**Re: FortisBC Energy Inc. (FEI)**

**Application for a Certificate of Public Convenience and Necessity (CPCN) for  
Approval of the Interior Transmission System Transmission Integrity  
Management Capabilities Project (Application)**

**Response to the Residential Consumer Intervener Association (RCIA)  
Information Request (IR) No. 2**

**Figure 1: Event 1 – SAV VER 323**

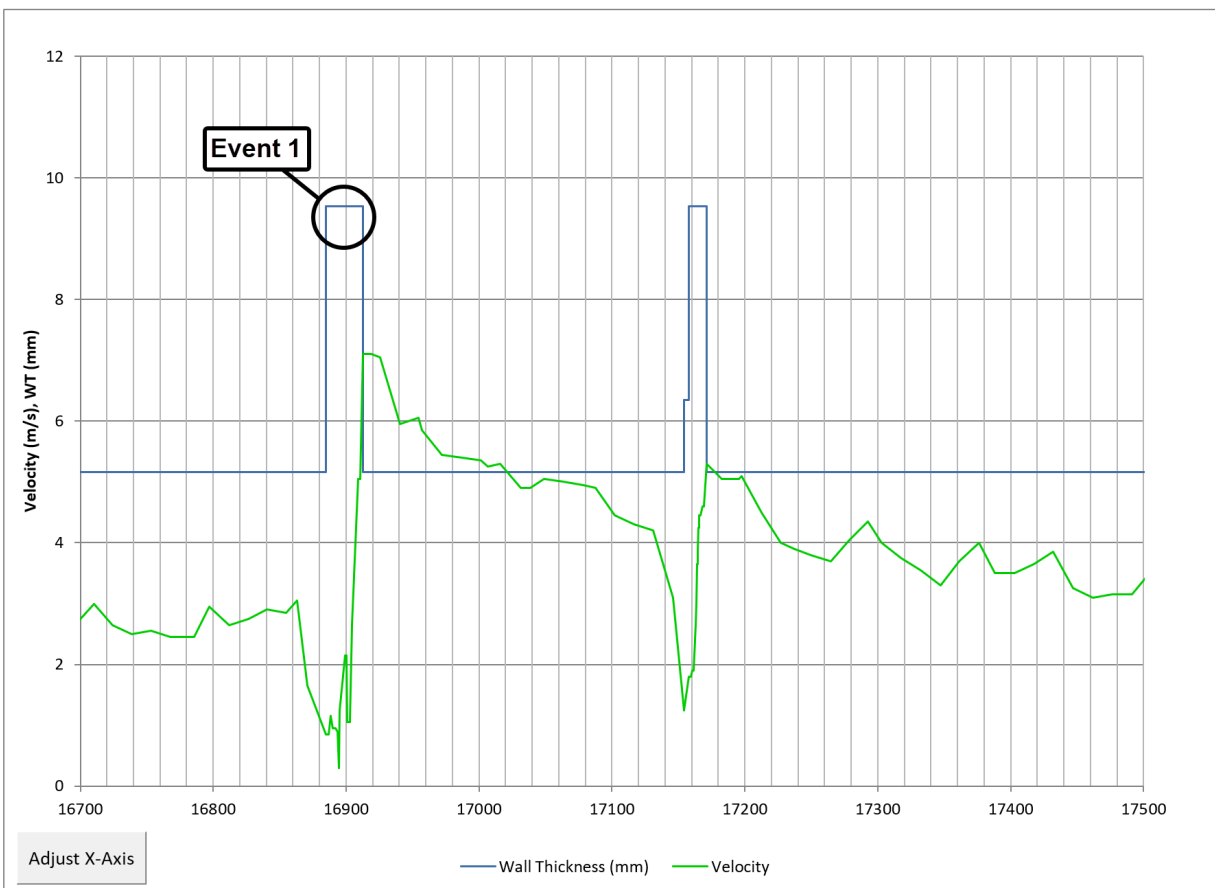
21.3 Provide the speed profiles of the previously run MFL-C tools showing their speeds as they pass the heavy wall sections proposed for removal (i.e., Events 1, 29, and 31) until a point downstream where the tool speed has returned to its optimal velocity range.

2    Please refer to the figures below showing the velocity (or speed) profiles of previously run MFL-  
3    C tools as they pass the heavy-wall sections proposed for removal until a point downstream where  
4    the tool speed has returned to its optimal velocity range (1-3 m/s as per Section 3 of Appendix F  
5    to the Application).

6    FEI notes that when quantifying the lengths of downstream pipe impacted provided in Table 5-4  
7    of the Application, it focused on segments where the MFL-C tool was traveling above the  
8    maximum velocity for full resolution data (5 m/s as per Section 3 of Appendix F to the Application).

(ii) VER PEN 323

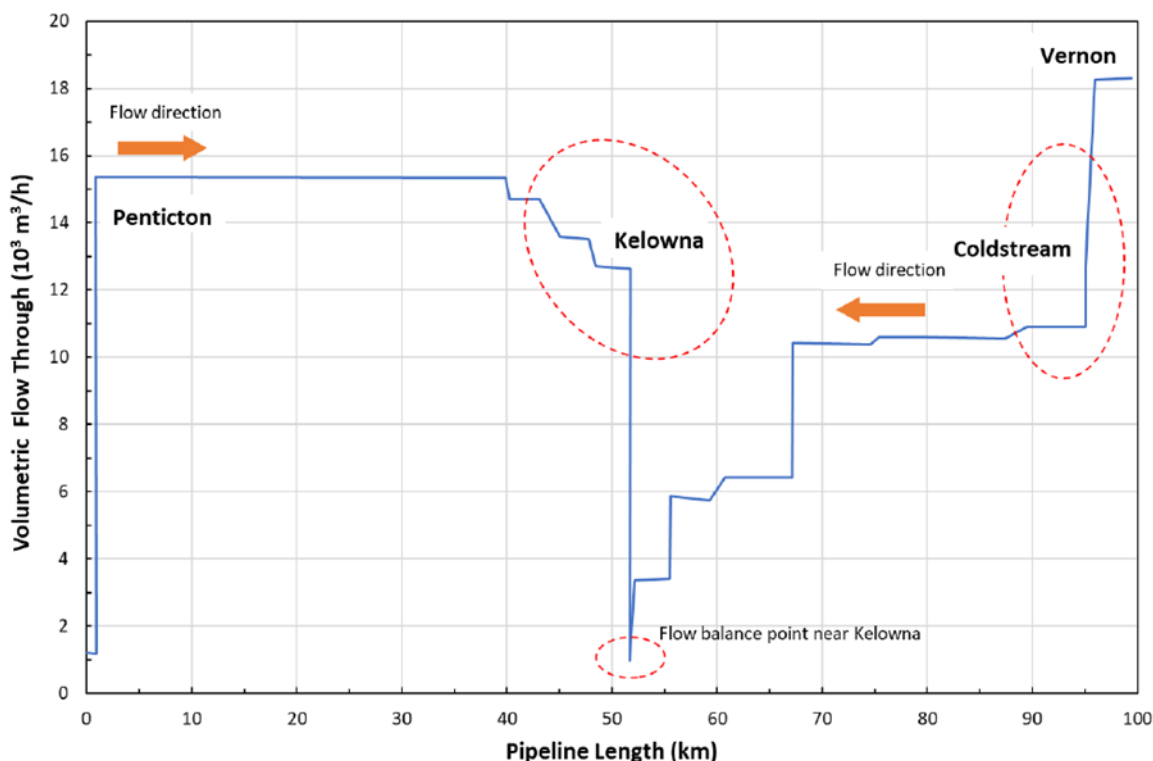
In its response to RCIA IR1 12.3, FEI provides the following graph of flow rate versus pipeline length.

As explained in the response to RCIA IR1 12.3, the graph provided in the preamble represents flow conditions on the VER PEN 323 pipeline for a typical cool summer day. However, during in-line inspections, FEI plans to adjust gas pressure and flow conditions in an effort to keep the ILI tool within its optimal velocity range. On the VER PEN 323 pipeline, ILI tools are typically launched at Pentiction and travel towards Vernon to the receiver barrel.

FEI plans to maintain the EMAT tool within its optimal velocity range during the inspection of the VER PEN 323 pipeline using the bidirectional flow control stations (FCS) proposed to be installed at Pentiction Gate and SN-7 (Vernon), in coordination with existing pressure control facilities. FEI also provided an explanation of how the FCS will operate in the response to RCIA IR1 12.1.
